# Proposed Home Plans

## 1721 Lake Avenue

REVISED 7/19/20  
 APP 20207934

REVIEWED JUL 20 2020  
 RESIDENTIAL REVIEWED  
 APPROVED SUBJECT TO ATTACHED COMMENT SET AND FINAL INSPECTION.  
 M  
 Plan Review Center

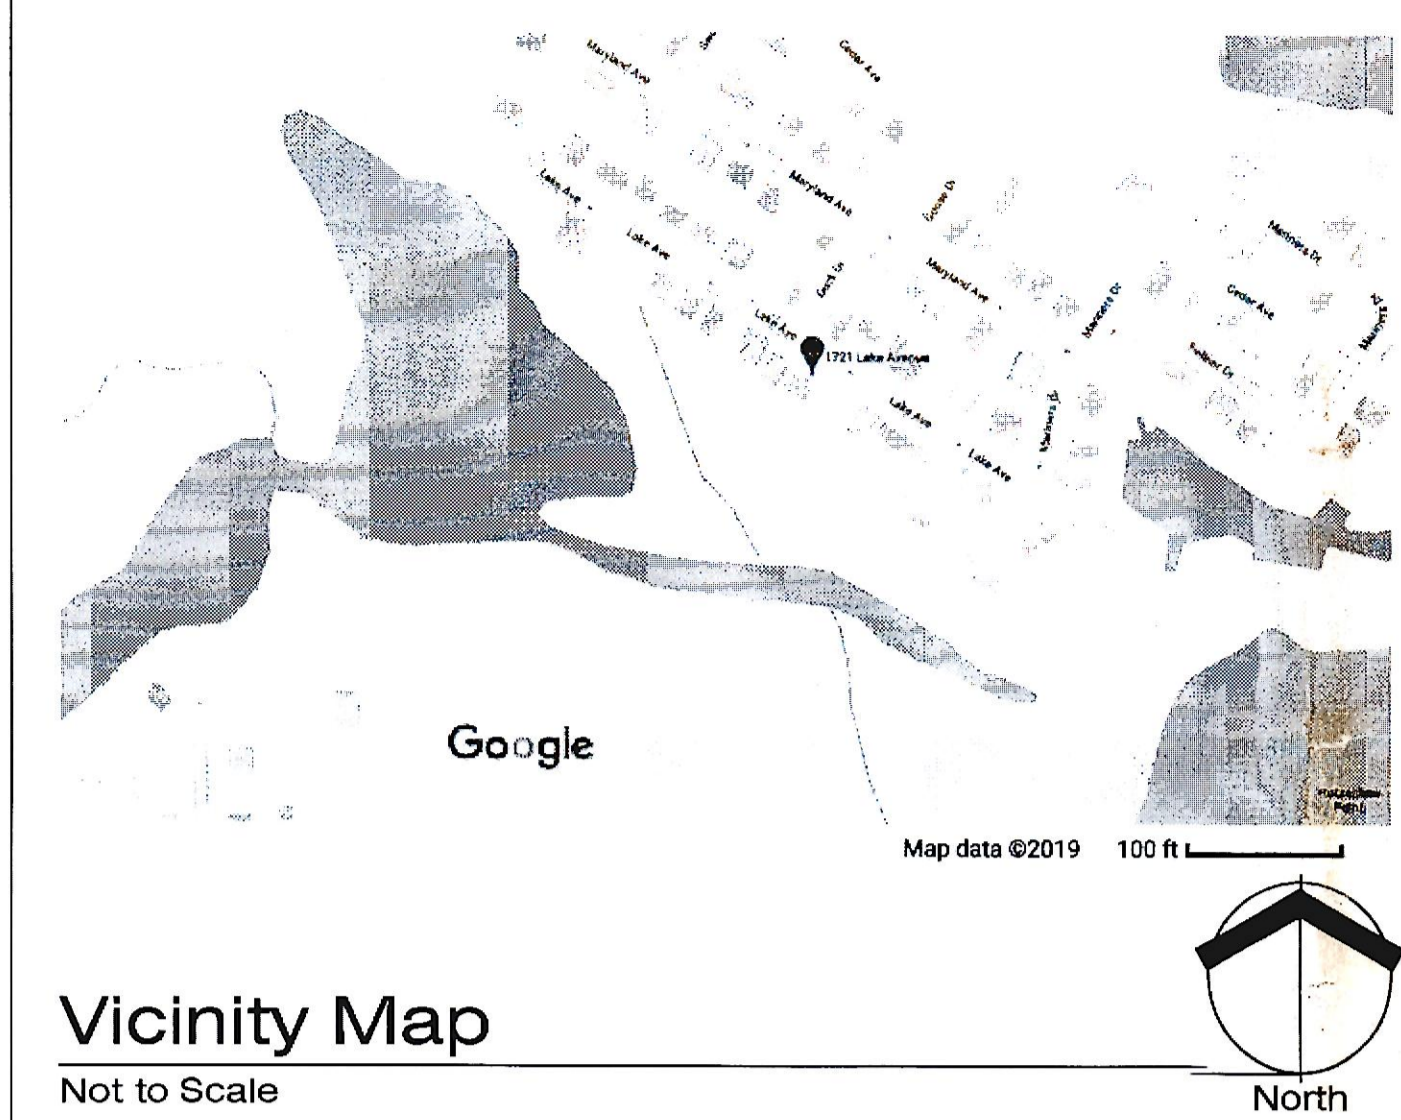
2015 IRC  
 Per Anne Arundel County Code, an automatic sprinkler system, per NFPA 13D, shall be provided. Submit Sprinkler Shop Drawings for approval prior to initiation of work.
